LAND USE APPLICATION COMPLETENESS REVIEW

Subject Property: 1105 Front Street NE

Reference Nos.: 24-106451-PLN (Class 3 Site Plan Review, Tentative Subdivision Plan, Class 1 & 2 Adjustment, Class 2 Driveway Approach Permit)

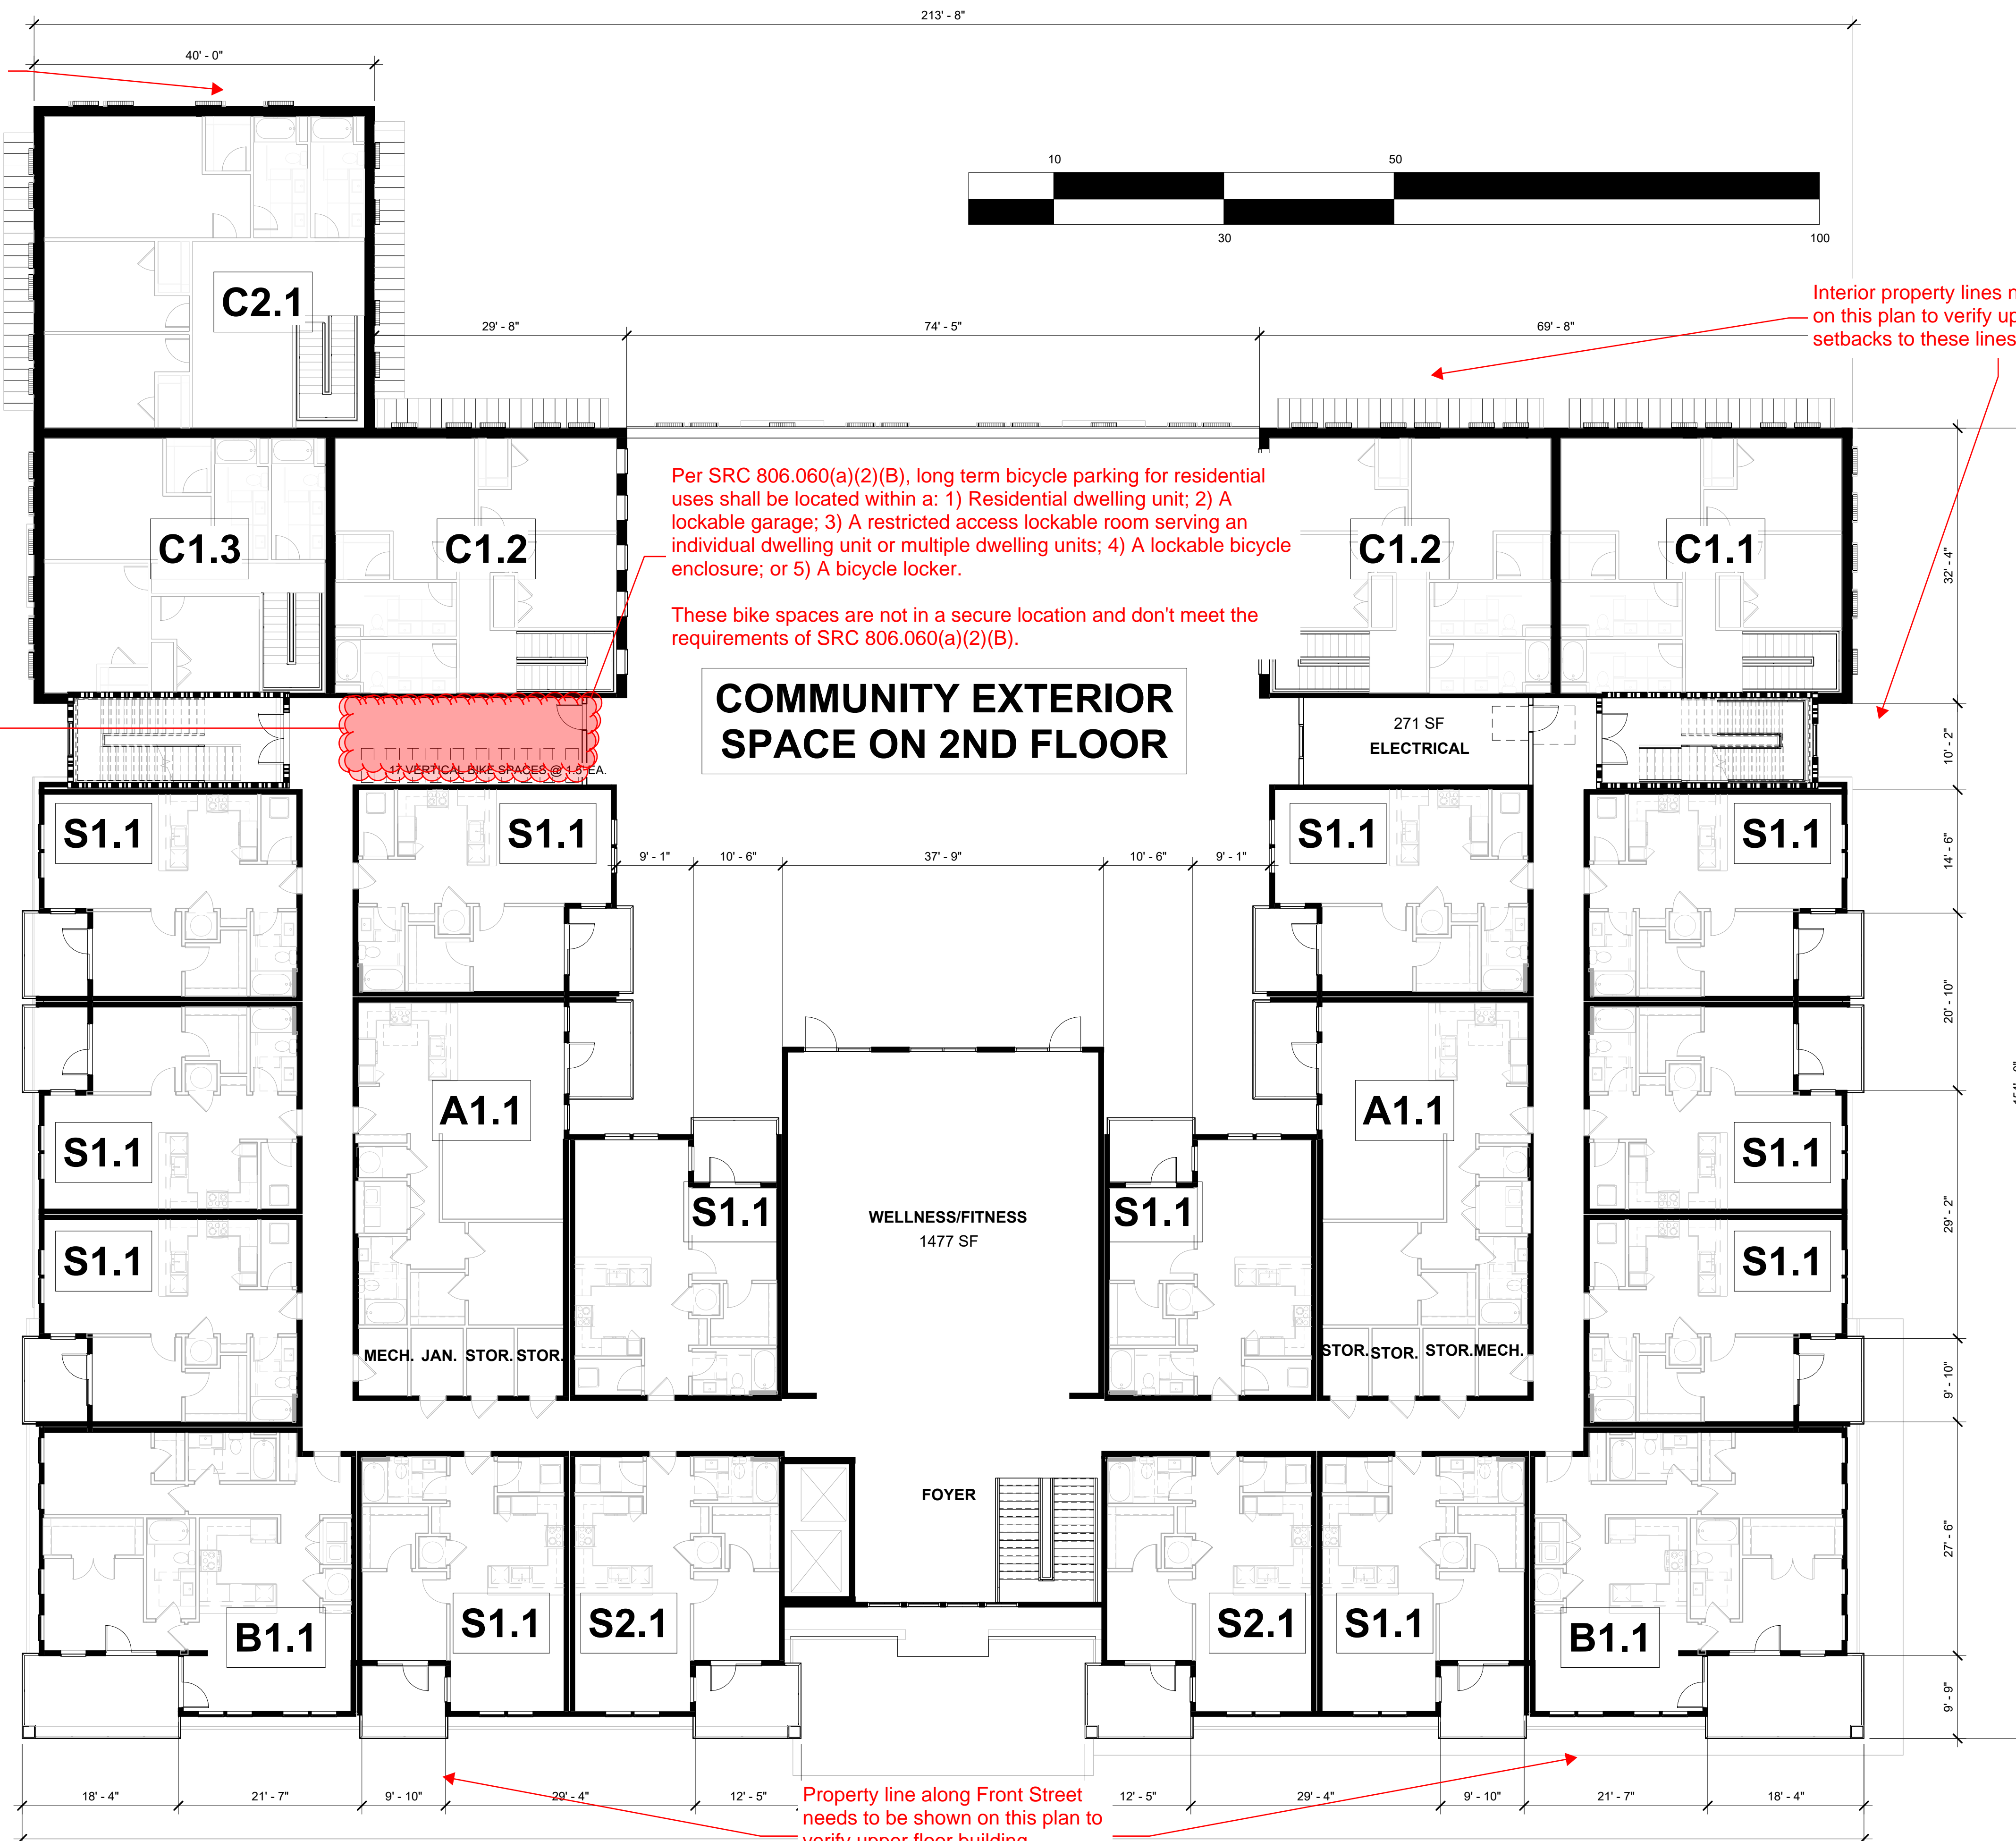
Interior property lines need to be shown on this plan to verify upper floor building setbacks to these lines.

Interior property lines need to be shown on this plan to verify upper floor building setbacks to these lines.

Detail drawing needed showing the layout of each bike space in relation to the proposed vertical bike racks.

Per SRC 806.060(a)(2)(B), long term bicycle parking for residential uses shall be located within a: 1) Residential dwelling unit; 2) A lockable garage; 3) A restricted access lockable room serving an individual dwelling unit or multiple dwelling units; 4) A lockable bicycle enclosure; or 5) A bicycle locker.

These bike spaces are not in a secure location and don't meet the requirements of SRC 806.060(a)(2)(B).

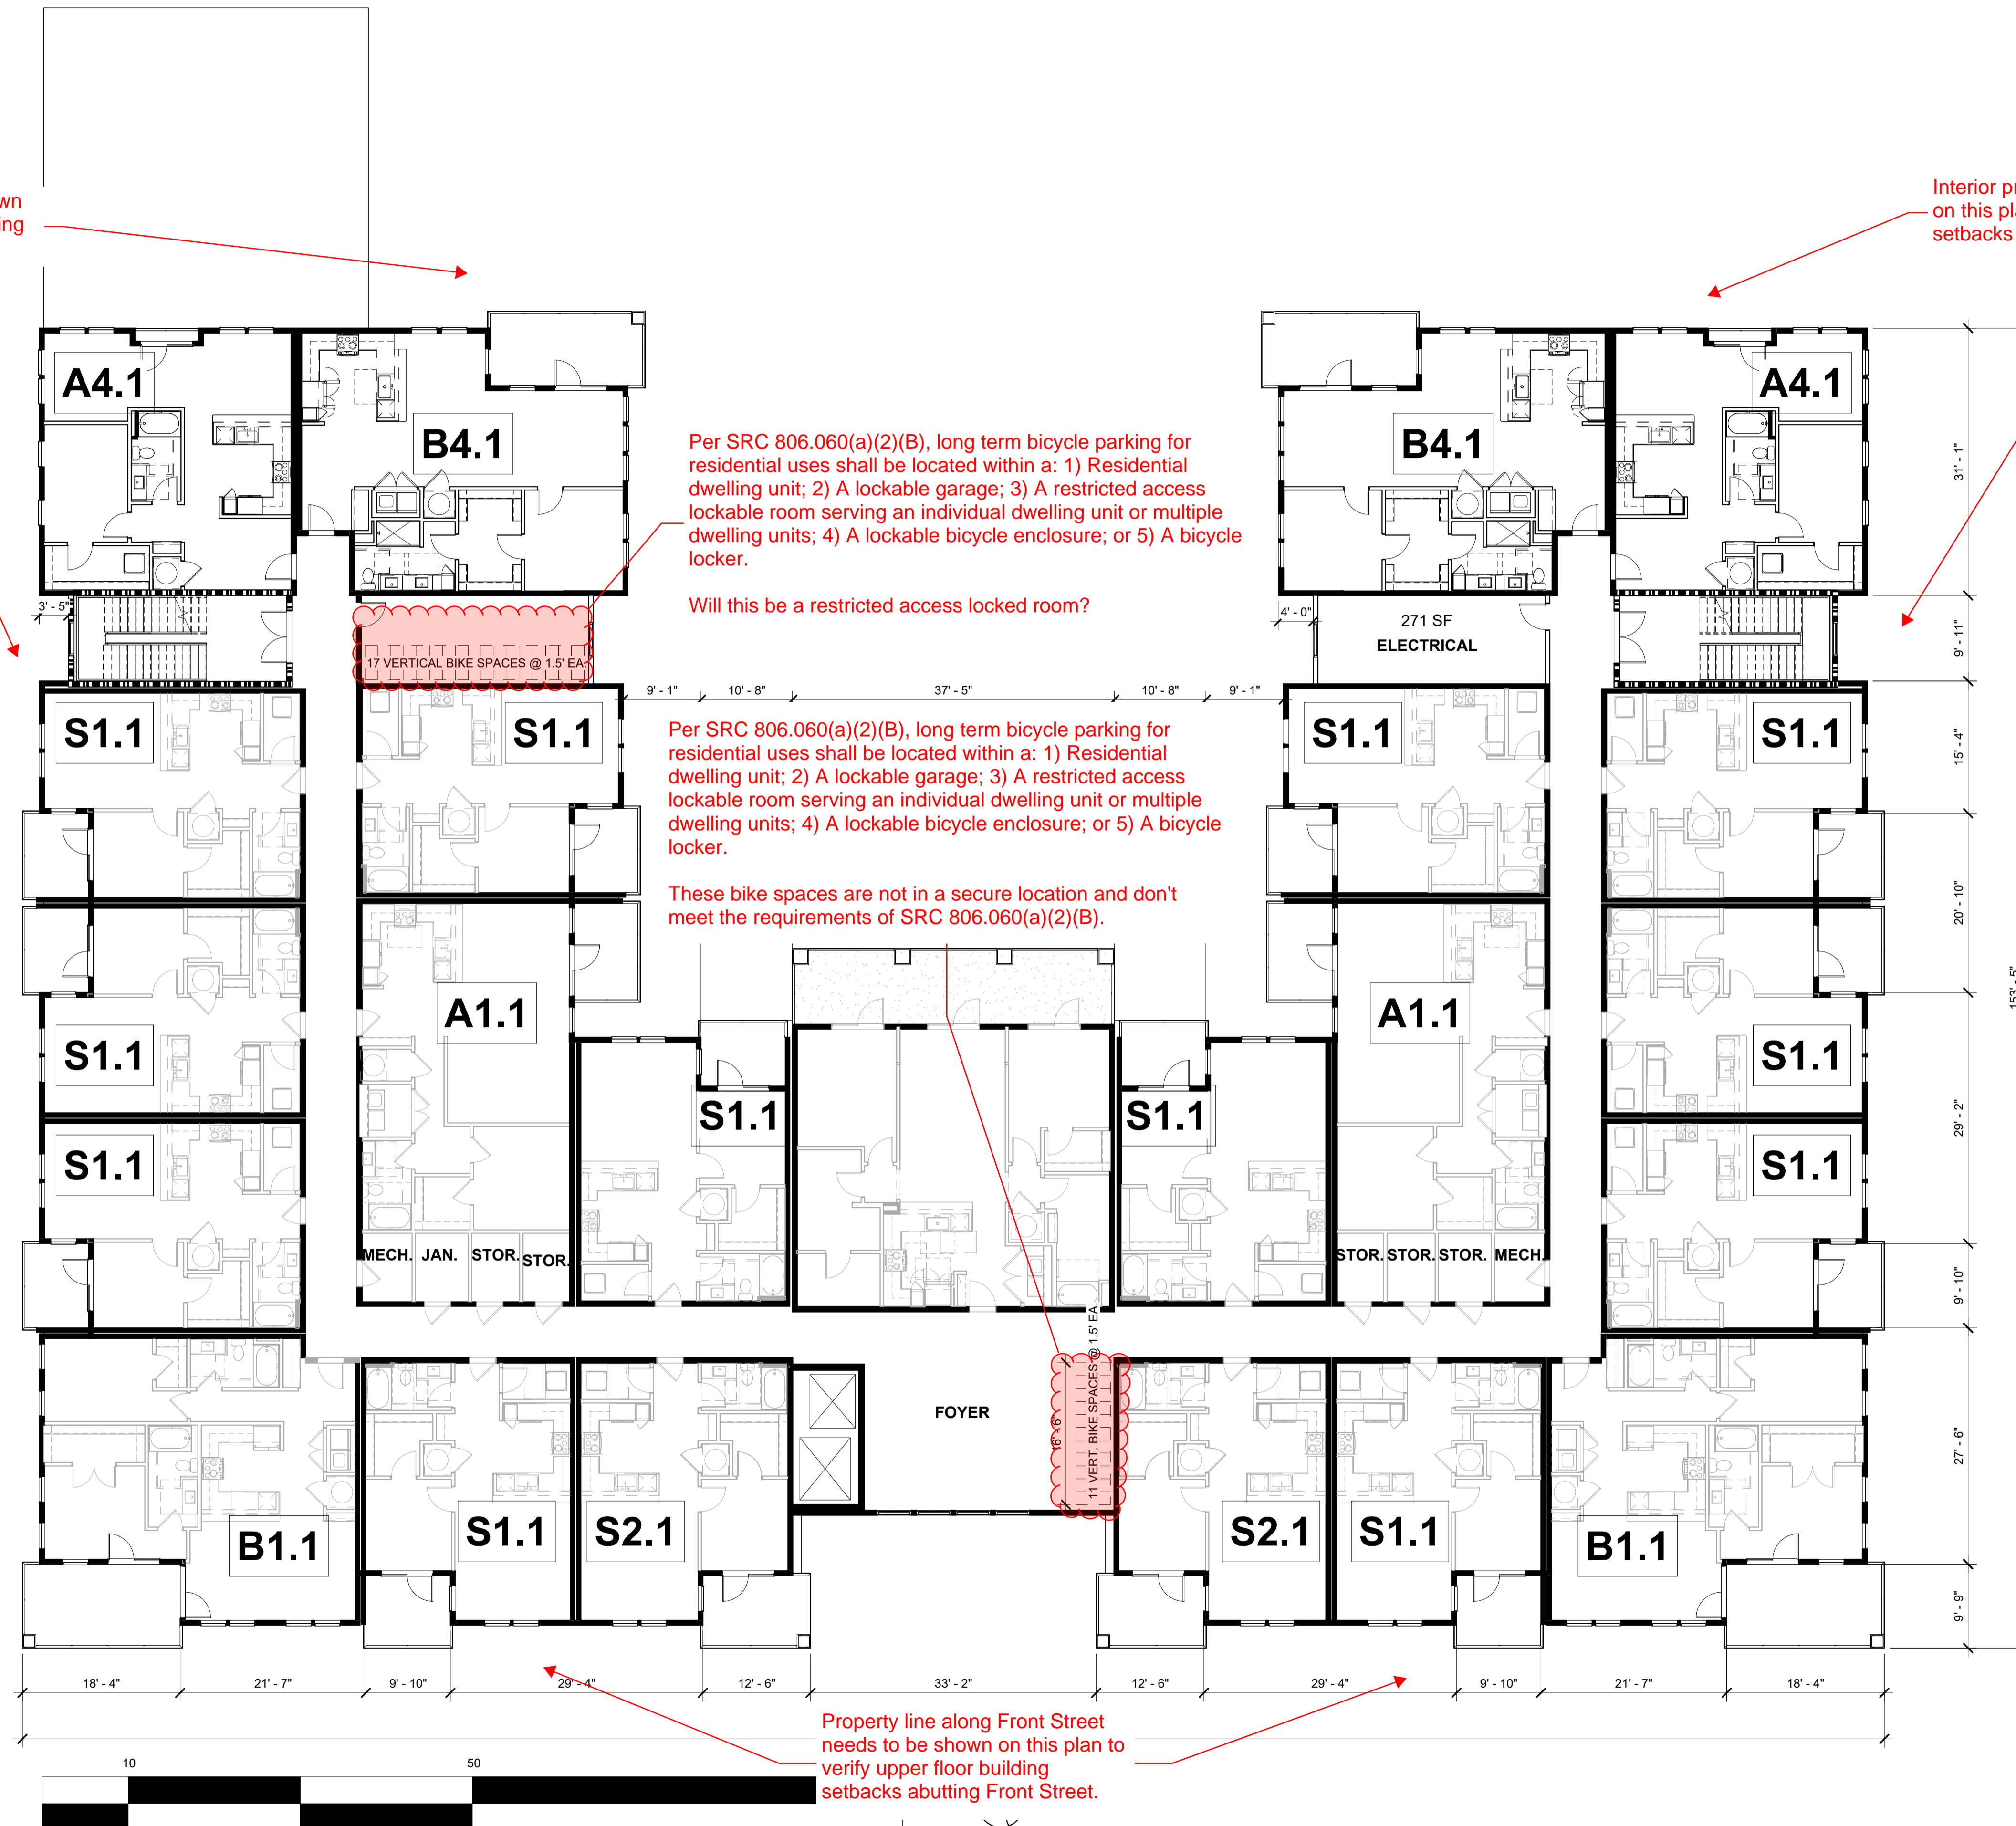
Property line along Front Street needs to be shown on this plan to verify upper floor building setbacks abutting Front Street.

Interior property lines need to be shown on this plan to verify upper floor building setbacks to these lines.

Interior property lines need to be shown on this plan to verify upper floor building setbacks to these lines.

Per SRC 806.060(a)(2)(B), long term bicycle parking for residential uses shall be located within a: 1) Residential dwelling unit; 2) A lockable garage; 3) A restricted access lockable room serving an individual dwelling unit or multiple dwelling units; 4) A lockable bicycle enclosure; or 5) A bicycle locker.

Will this be a restricted access locked room?
